Subject: Indian Point 3 Nuclear Power Plant
Docket No. 50-286
Electrical Override/Bypass Aspects of ESFs

ATTACHMENT I

ELECTRICAL OVERRIDE/BYPASS ASPECTS OF THE
ENGINEERED SAFETY FEATURES

POWER AUTHORITY OF THE STATE OF NEW YORK
INDIAN POINT 3 NUCLEAR POWER PLANT
DOCKET NO. 50-286
OCTOBER 15 , 1980

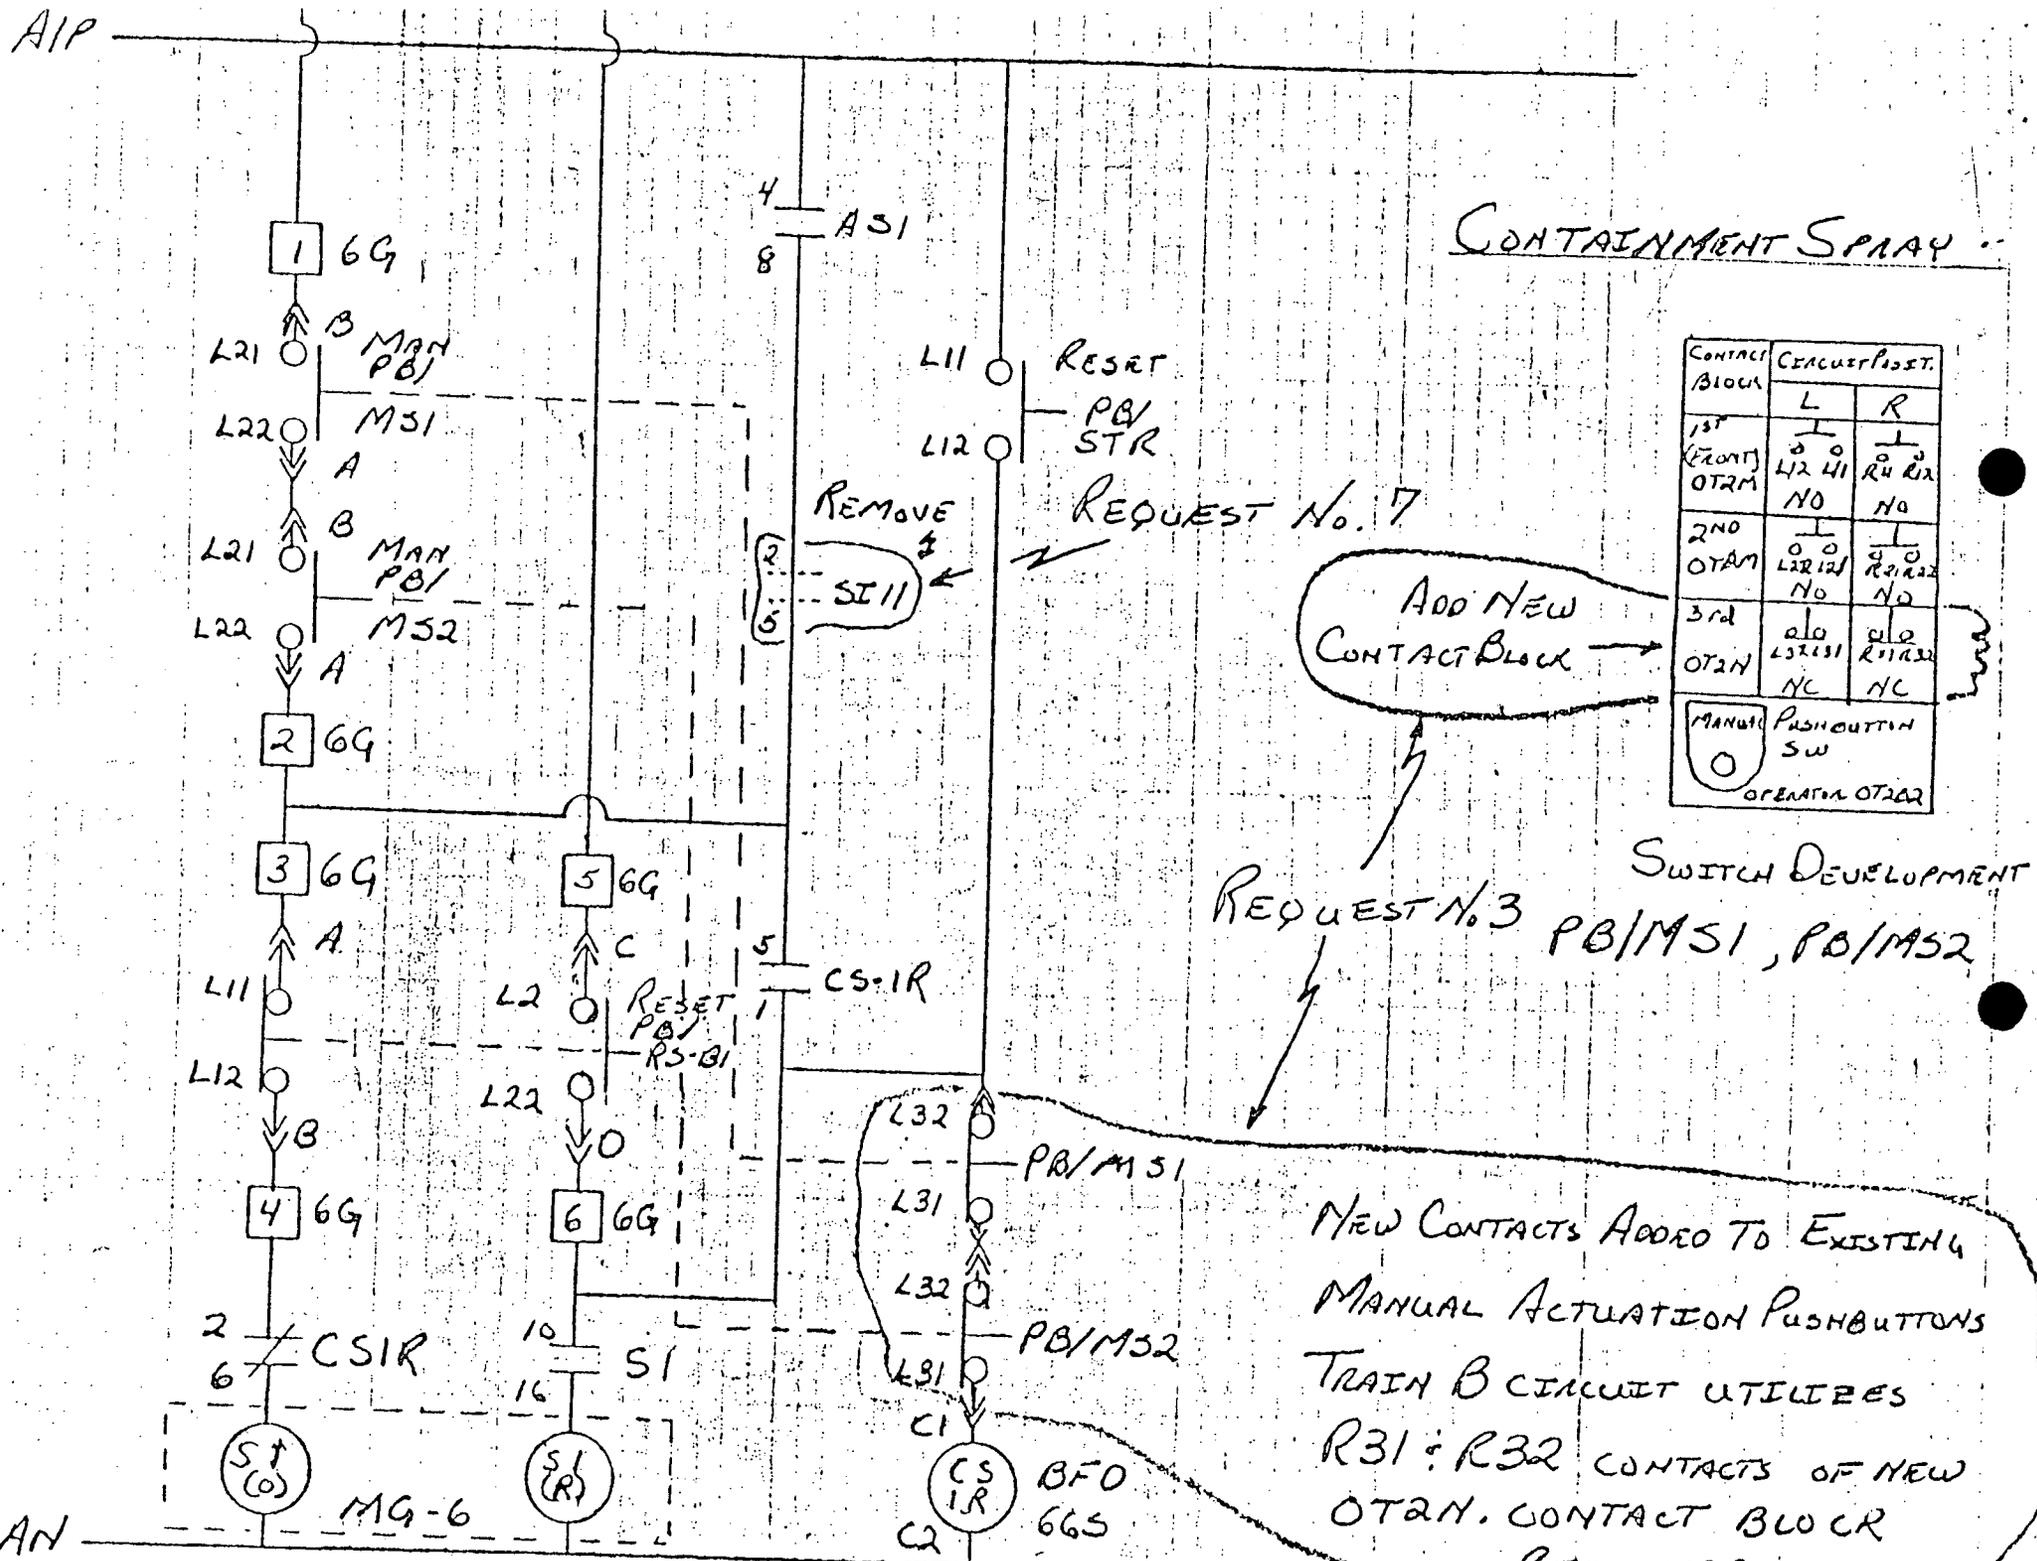
7. It appears that both an SI signal and a containment high-high pressure signal are required to automatically actuate the CS system. The SI signal may have been re-set before the containment high-high pressure set point is reached, precluding automatic actuation of the CS system. Describe your proposed modification that will allow automatic actuation of this CS system whenever it is required.

The contacts that are in the Containment Spray System actuation circuitry from the Safety Injection System Relays, SI 11 and SI 12 will be removed from the actuation circuitry. This modification will ensure that the automatic actuation of the Containment Spray System will energize the system at the Containment high-high pressure set point. See figure 7.1.

The removal of these contacts from the Containment Spray circuitry will be completed during a scheduled outage of sufficient duration.

SCHEMATIC DIAGRAM
480V MOTOR CONTROL CENTER 37
SHEET NO. 7

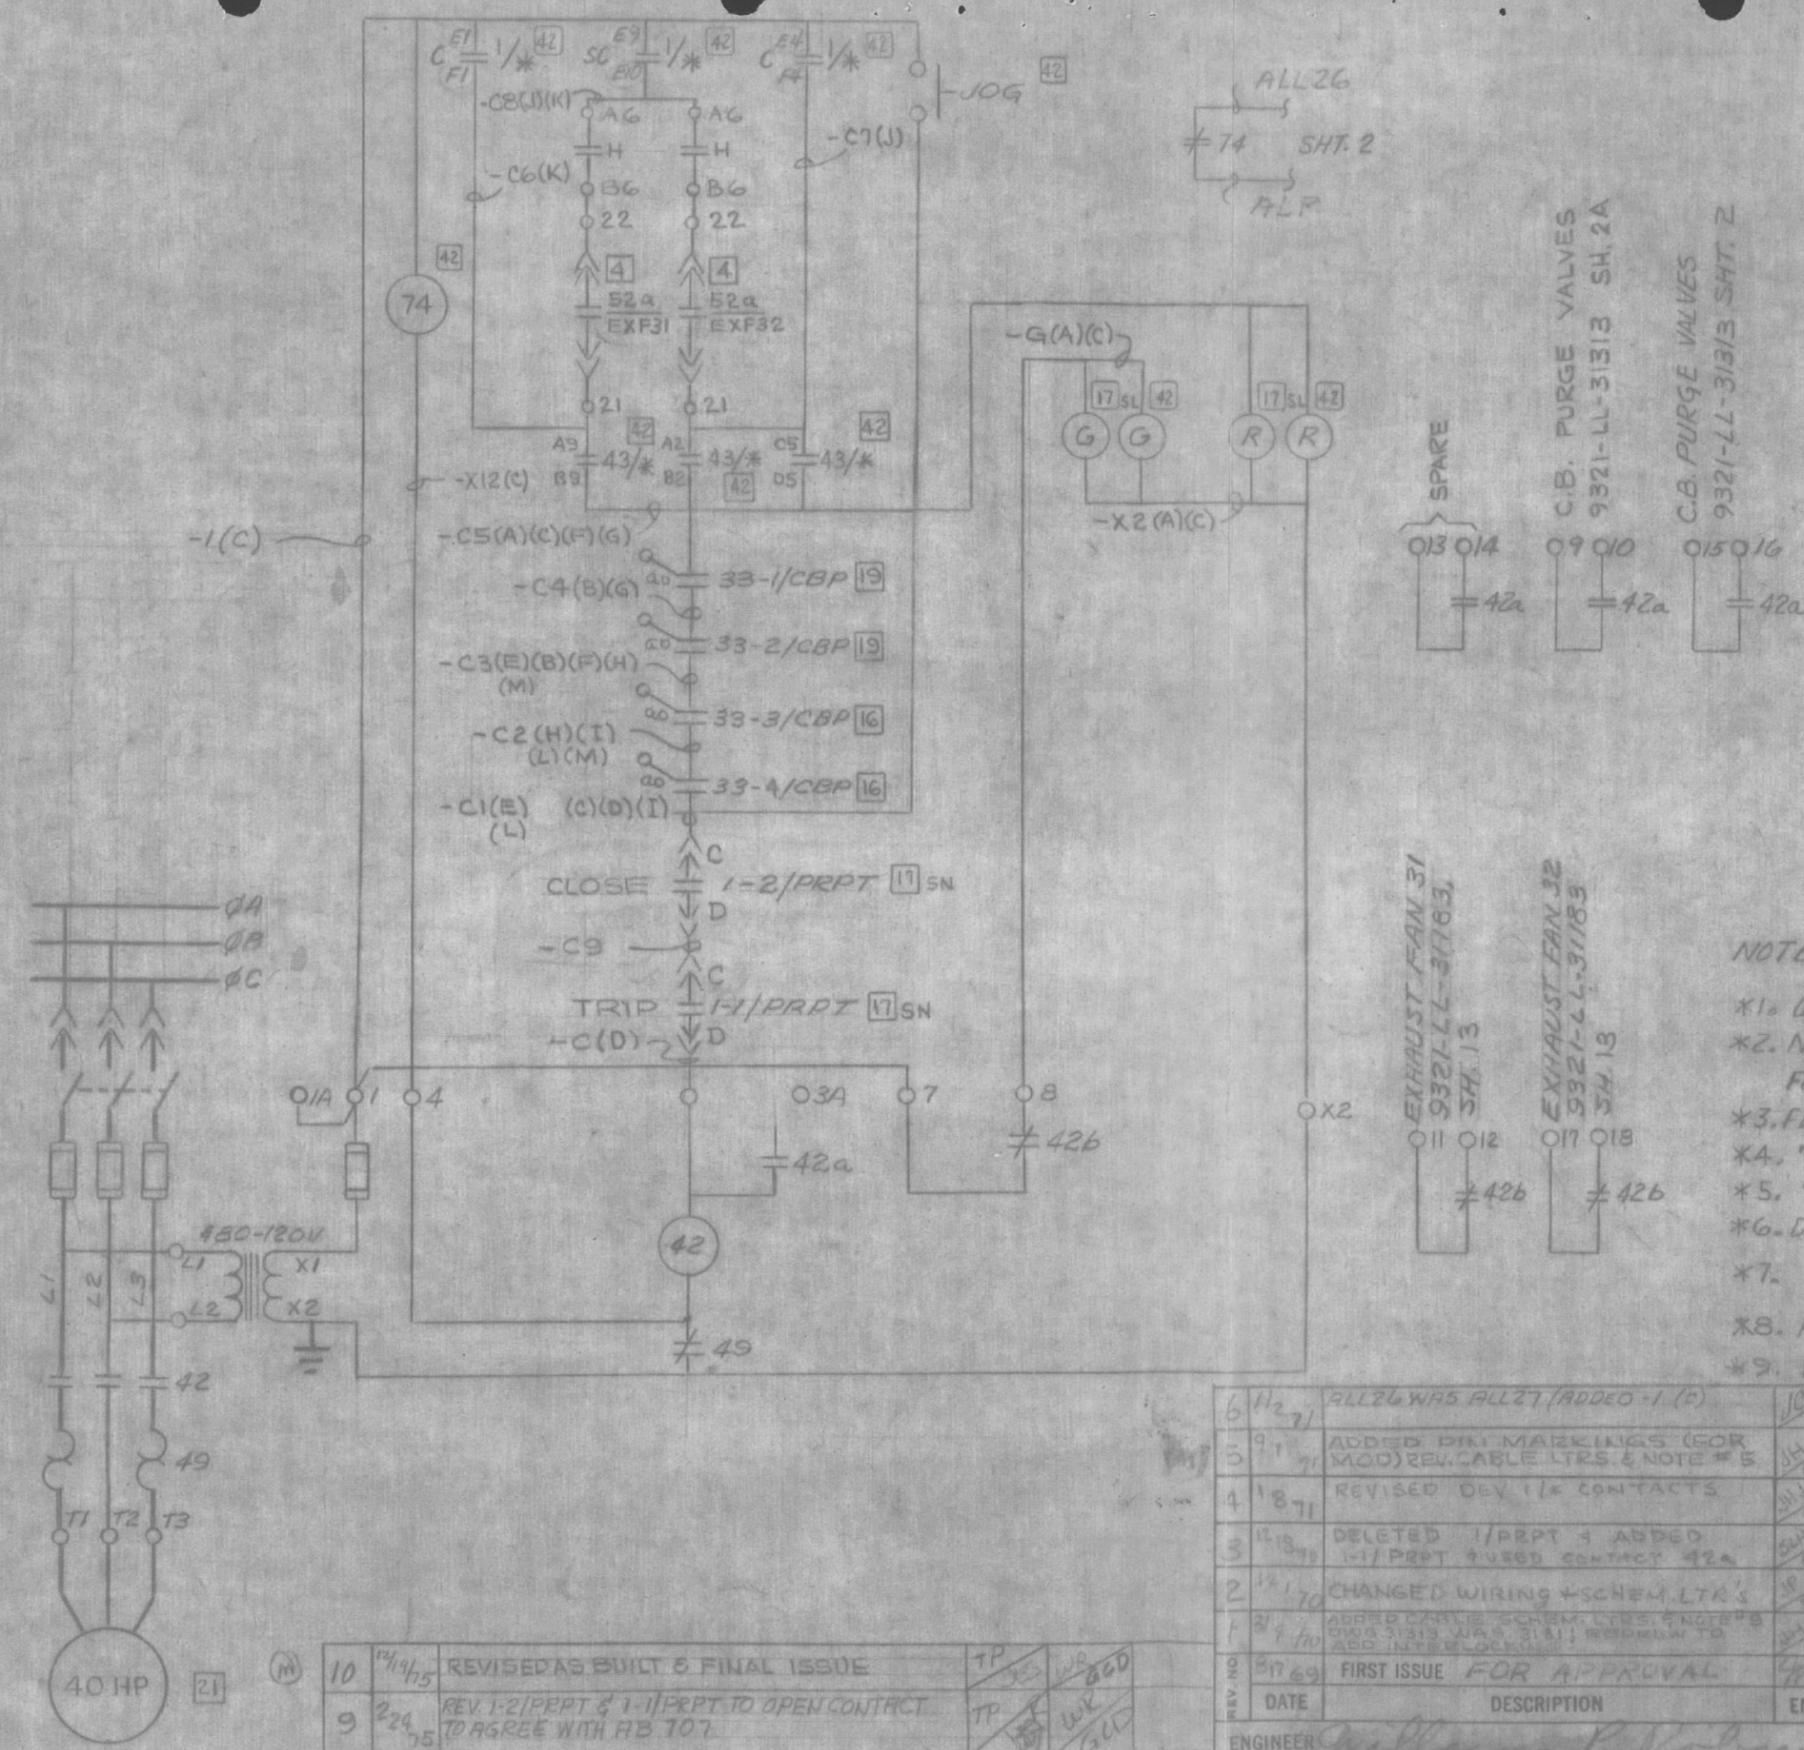
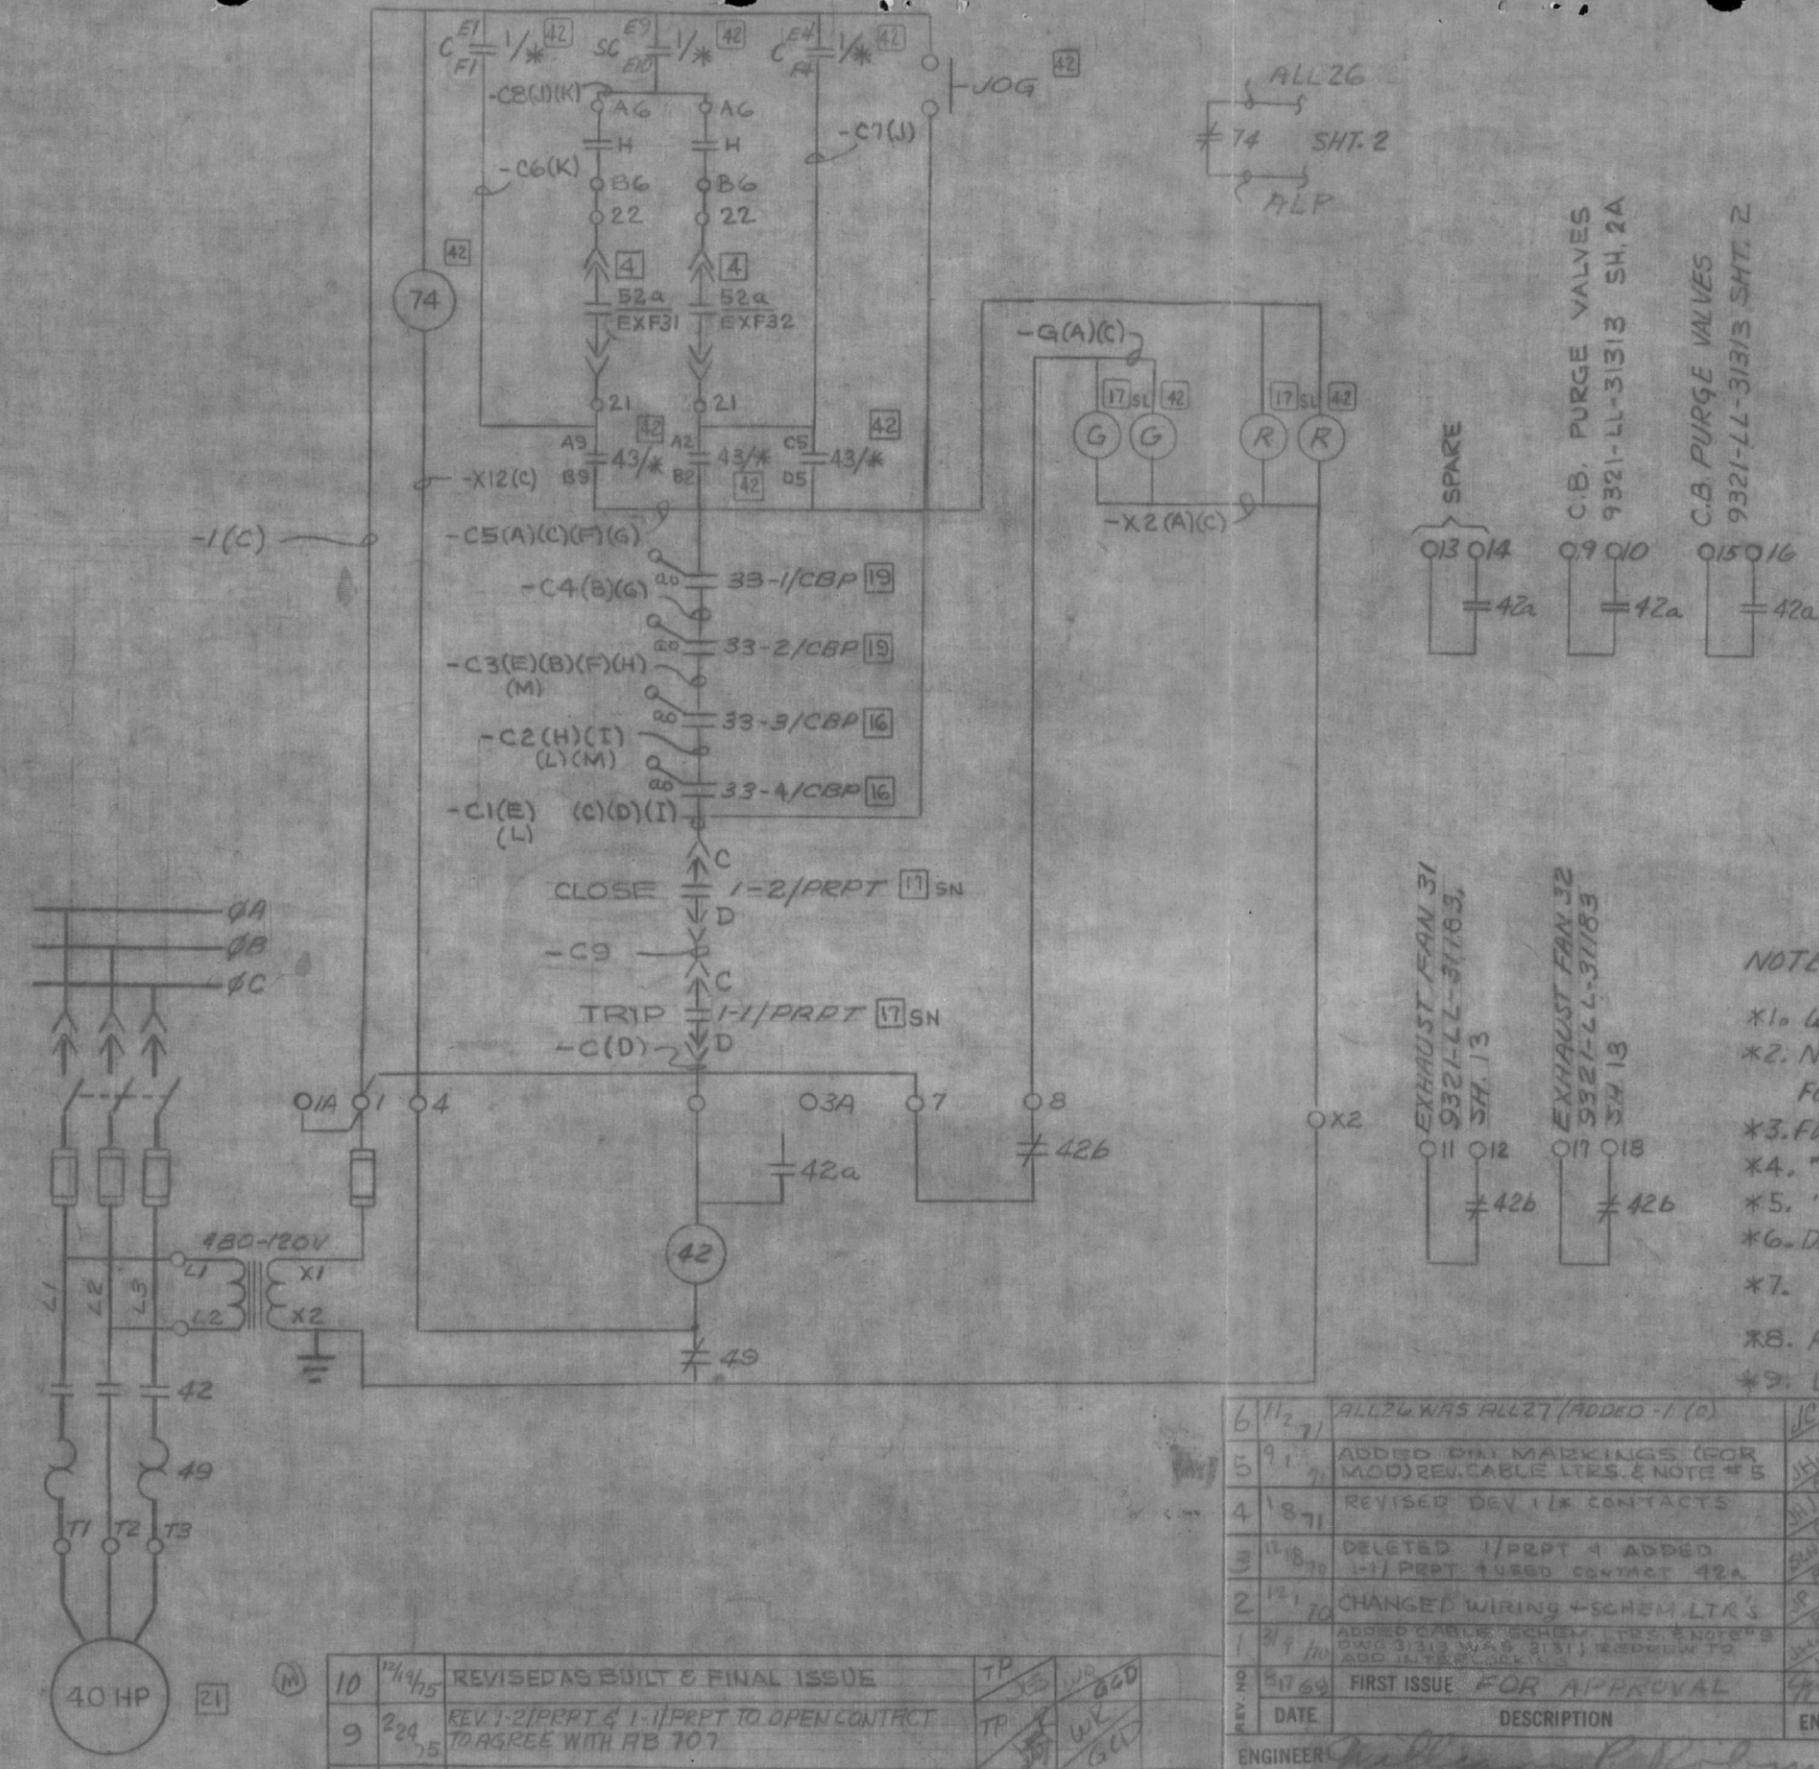
8. Provide drawings showing the circuitry which operates relay 42A/CBPF.

Drawing Number 9321-LL-31273 sheet No. 7, "Schematic Diagram 480V. Motor Control Center 37" shows the circuitry of the Containment Building Purge Supply Fan (CBPF) and is attached for your information.
